Product Change Notification / ALAN-14CQYK486

CCB 3582.001 Final Notice: Qualification of inductor LQM21PNR47MCH# for selected Micrel MIC38150HYHL-TR catalog part number (CPN) available in 28L VQFN (4x6x0.9mm) package.

PCN#: ALAN-14CQYK486

CCB 3582.001
Pre and Post Change Summary
PCN# ALAN-14CQYK486

Pre Change

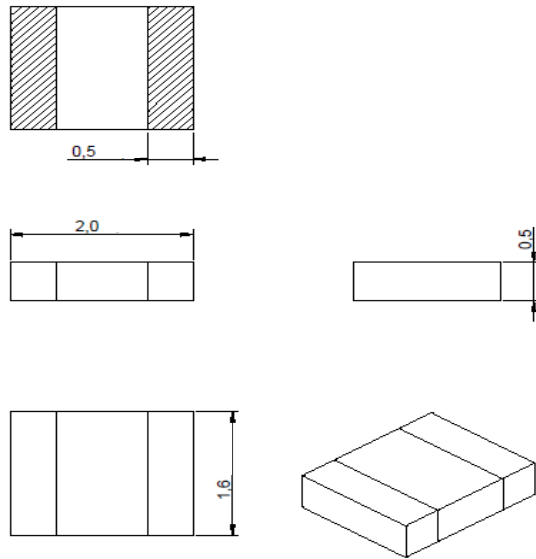
Inductor Part Number	74479977147
Package dimension	2 x 1.6 x 0.5 mm

Post Change

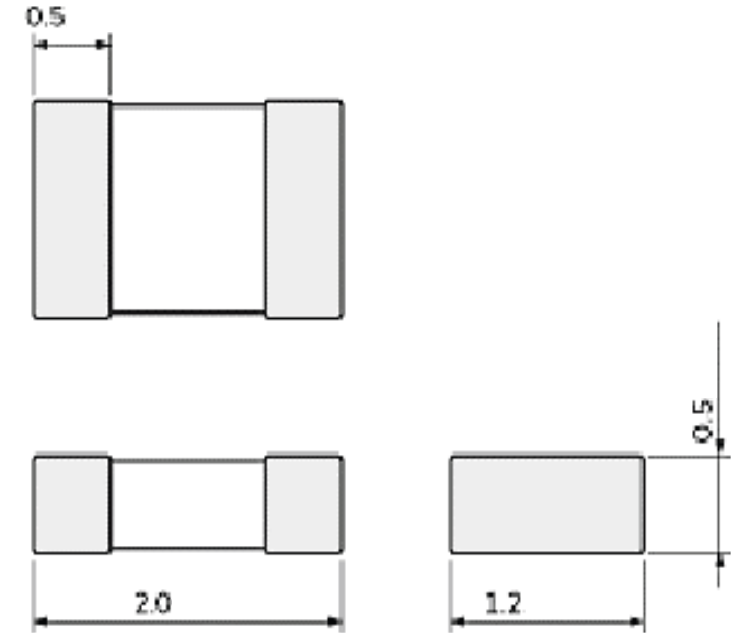
Inductor Part Number	LQM21PNR47MCH#
Package dimension	1.25 x 2.0 x 0.5 mm
